Re: APPROVAL OF PETITION FROM OLDE CHAPEL HILL, LLC. (FORMERLY BISHOP'S HILL, LLC.) – REQUESTING PLANNED DEVELOPMENT DISTRICT ON PARCELS AL-56-2, LOCATED AT 1921 RIVERSIDE DRIVE

Final PDD Review – Staff Comments

Site: 1921 Riverside Drive (Parcel AL-56-2)
Developer: Olde Chapel Hill, LLC. (formerly Bishop's Hill, LLC.)
Attn. Keith Garot

RE: Site Plan Reviewer comments from fire for 1921 Riverside Drive (Old Chapel Hill Residence)

PDD Layout

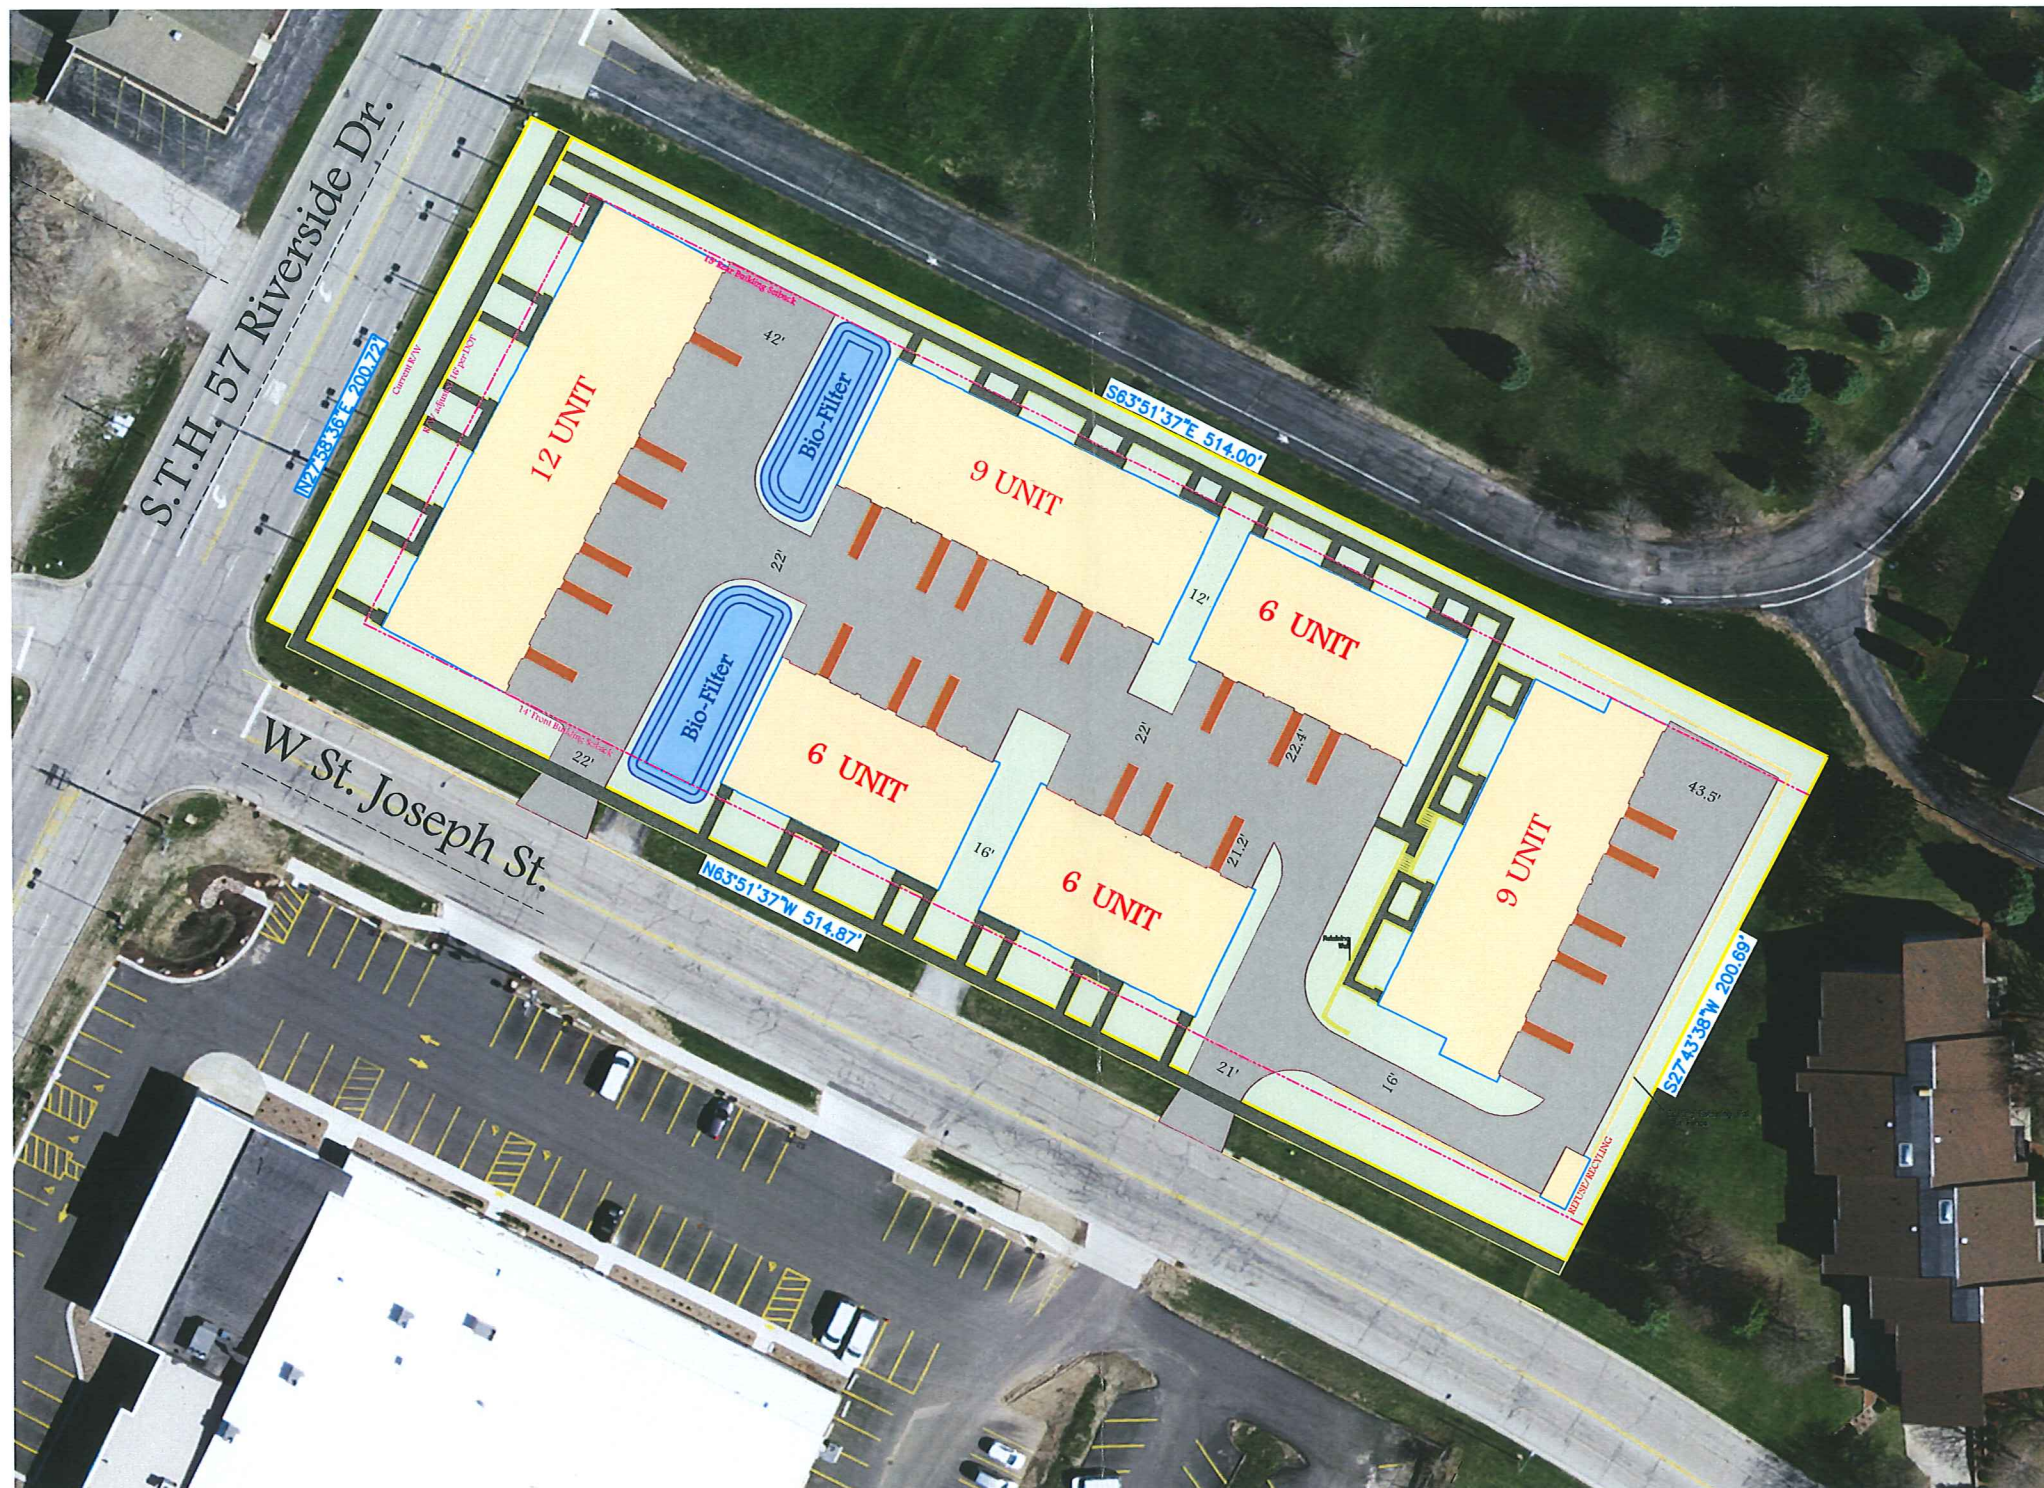
- The use is an allowed and existing use in the surrounding properties.
 - The setback is closer than what is allowed in the appropriate zoning district for the proposed use, but smaller setbacks are called for in the Comprehensive Plan [setback on Riverside Drive increased from preliminary to account for the future adjusted right of way (15' -> ~30'). Setback on W St. Joseph Street decreased from preliminary because of adjusted Riverside Drive ROW (15'->14')].

- Final review comments:
 - Detail of the trash enclosure should be provided. The trash enclosure should be screened using the same masonry materials used in primary structures. Additionally, concrete pavement should extend 30 feet out from dumpster to prevent wear from heavy equipment.

- Wall pack and coach lighting should be set to a timer or controlled by ambient light.
 - No exterior mechanical equipment is shown. All mechanical equipment should be enclosed or screened.

- Bicycle parking should be provided.
 - Pedestrian access should be provided from St. Joseph to the eastern most building.
 - Snow storage or removal should be addressed by the developer.

- Fire Department review:
 - Preliminary review comments met:
 - Concerns with maneuvering rigs through two sets of buildings and around the corner to get equipment out of the apartment complex. A secondary ingress/egress to the apartment complex located on West St. Joseph Street would address these concerns.

- If a secondary ingress/egress is provided, as noted in the Fire Department comments, it should be setback a minimum of 60' from the intersection.
 - Final review comments:
